**MEMORANDUM**  
Comfort Lake-Forest Lake Watershed District

**Date:** September 5, 2023  
**To:** CLFLWD Board of Managers  
**From:** Mike Kinney, District Administrator  
**Subject:** CLFLWD Permit 22-043 - Rolling Acres 61

<b>Project</b>	Rolling Acres 61	<b>Date</b>	9-5-2023
<b>To</b>	Mike Kinney	<b>Contact Info</b>	CLFLWD
<b>Cc</b>	Board of Managers	<b>Contact Info</b>	CLFLWD
<b>From</b>	Greg D. Graske, P.E.	<b>Contact Info</b>	EOR
<b>Regarding</b>	Permit Application #22-043, City of Scandia

**WETLAND BUFFER PLAN**  
**C3-4**

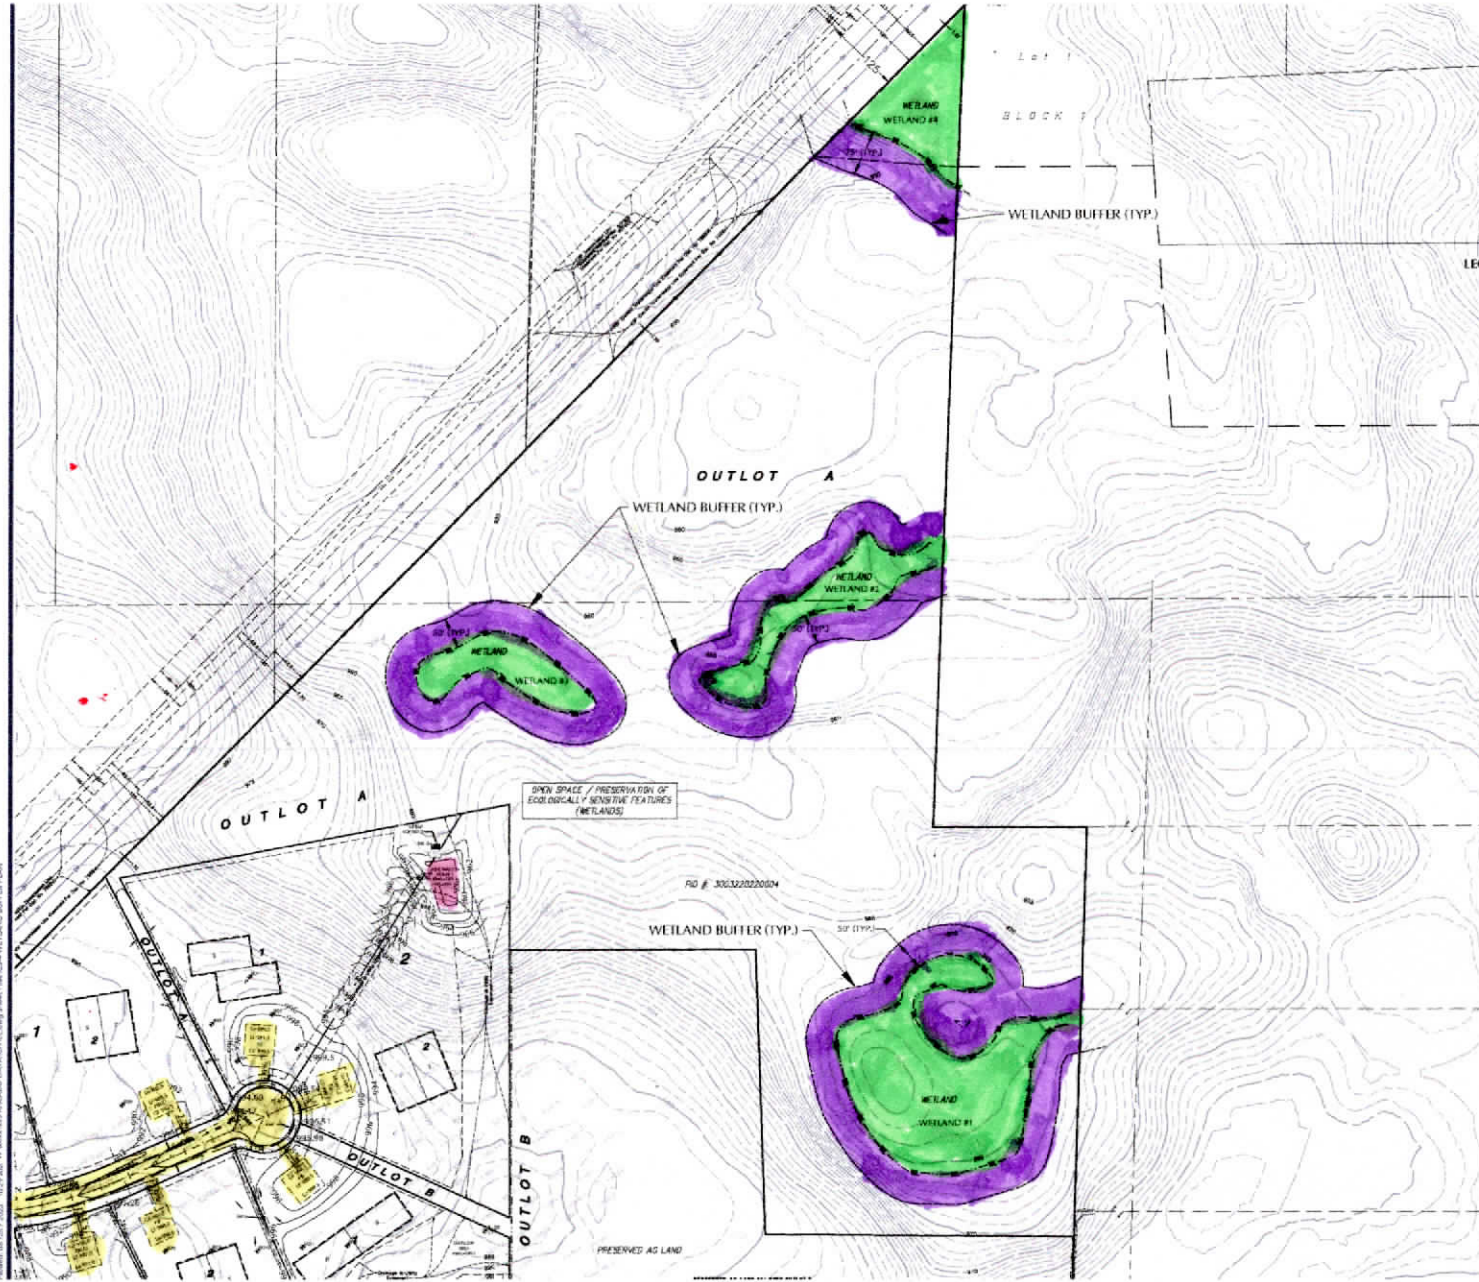
The land that is being subdivided includes four wetland areas. The applicant has provided a MnRAM indicating that one of these wetlands (Wetland 4) has a classification of Manage 1 and the other three wetlands have a classification of Manage 2. The buffer plan shows the required buffer areas around the wetlands. All the wetlands, buffer areas, and a significant amount of surrounding upland will be included in Outlot A. All of Outlot A will have a Perpetual Reinvest in Minnesota (RIM) Conservation Easement placed over it. The easement is administered by the Minnesota Board of Water and Soil Resources on behalf of the State of Minnesota. The conservation easement will require perpetual maintenance of the conservation area in an undisturbed state, and far exceeds the required buffer widths.

A vegetation survey has been completed indicating that the buffer areas exceed 30% undesirable species. Accordingly, sections 4.5.2 and 4.5.3 of the wetland buffer rule require that the applicant submit and implement a planting plan. A vegetation management plan has been provided for the conservation easement area including a detailed operations and maintenance plan for both grassland management and woody cover management. These plans include the types of activities needed to reduce the undesirable species onsite and, specifically, within the buffer area. The buffer maintenance instrument required as condition #2 above must incorporate this plan as it applies to the buffer area.

4. Buffer/Conservation Area markers shall be placed prior to any lot grading or home construction. Markers shall be placed at each lot line, with additional markers at an interval of no more than two hundred (200) feet.
5. A permit transfer will be required for each individual lot from the developer to the home builders. In conjunction with transfer, a site plan with lot specific erosion control requirements will be required. See the District website for lot specific erosion control requirements.
6. A final copy of the fully executed RIM conservation easement over Outlot A shall be provided to the District.
7. Implementation of the submitted Operations & Maintenance plan for the required buffer area.
8. Submittal of as-built survey for all stormwater features and pipe.
